PROFESSIONAL RECOMMENDATION MEMORANDUM

Project Name: Engineering Support Services and Recommendations for Roadside Safety Issues/Problems for Member States

Task 22-18: WSDOT Low-Profile Median Barrier Evaluation

Figure 2 WSDOT Low-Profile Barrier Cross Section.

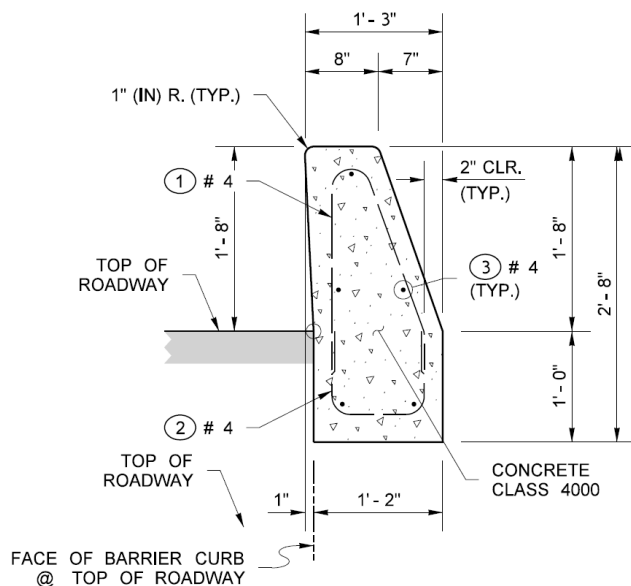
As it is presented in Figure 2, one key feature of this barrier system is its negative slope profile shape on the traffic side. This design is intended to help redirect vehicles away from the barrier in the event of a collision, which can help to mitigate the severity of the impact and prevent more serious accidents from occurring. The barrier is reinforced with #4 rebars spaced at a maximum of 18 inches throughout the wall. The maximum distance between the expansion joints is 36 feet (Figure 3).

The WSDOT permanent low-profile barrier has not undergone MASH Test 2-10 and 2-11, while both tests have been successfully performed on the Florida Department of Transportation (FDOT) permanent low-profile barrier (1). Despite this difference, the WSDOT barrier, which stands at a height of 20 inches, satisfies the minimum height requirements for MASH TL-2. It is worth noting that the FDOT barrier's cross-sectional profile is more critical in terms of vehicle stability than the negative slope face of the WSDOT barrier. Nevertheless, the WSDOT permanent low-profile barrier is deemed satisfactory in terms of its profile shape.

Figure 3 WSDOT Low-Profile Barrier Elevation View.

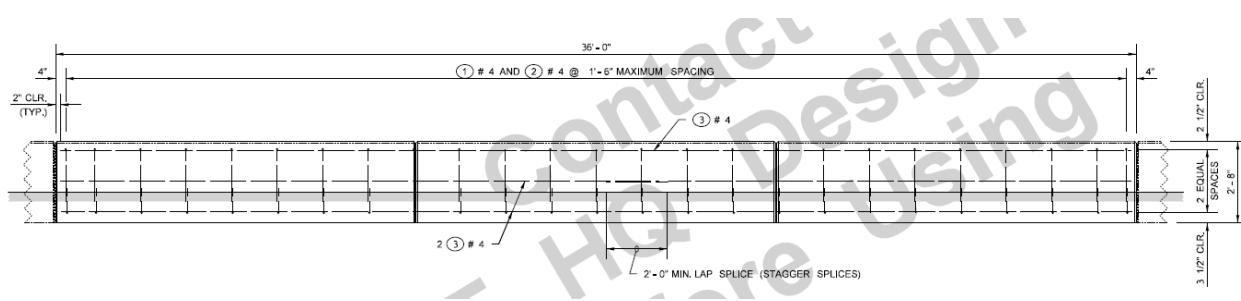
According to the LRFD analysis, the WSDOT low-profile barrier is structurally adequate at the mid-wall region when 18-inch vertical rebar spacing is used. However, the analysis has identified that the end of the wall, particularly the area close to the joints, may require additional reinforcement to ensure adequate strength.

The results of these assessments indicate that the system is more susceptible to overturning than sliding forces during impact. The minimum sliding length and minimum overturning length of the low-profile barrier system were calculated to be 27 ft and 30 ft, respectively. Therefore, to

To provide the necessary structural support to the end of the wall, it is recommended to reduce the spacing between the vertical reinforcement elements to a maximum of 11 inches. The reduction in spacing should begin at a distance of 5 feet from the end of the wall segment (expansion joints). This will allow for the proper formation of a yield line, which is critical in ensuring the structural strength of the wall in this area.

provide a stable response to a MASH TL-2 impact, a minimum segment length of 30 ft between expansion joints is required to resist the overturning of the system during impact.
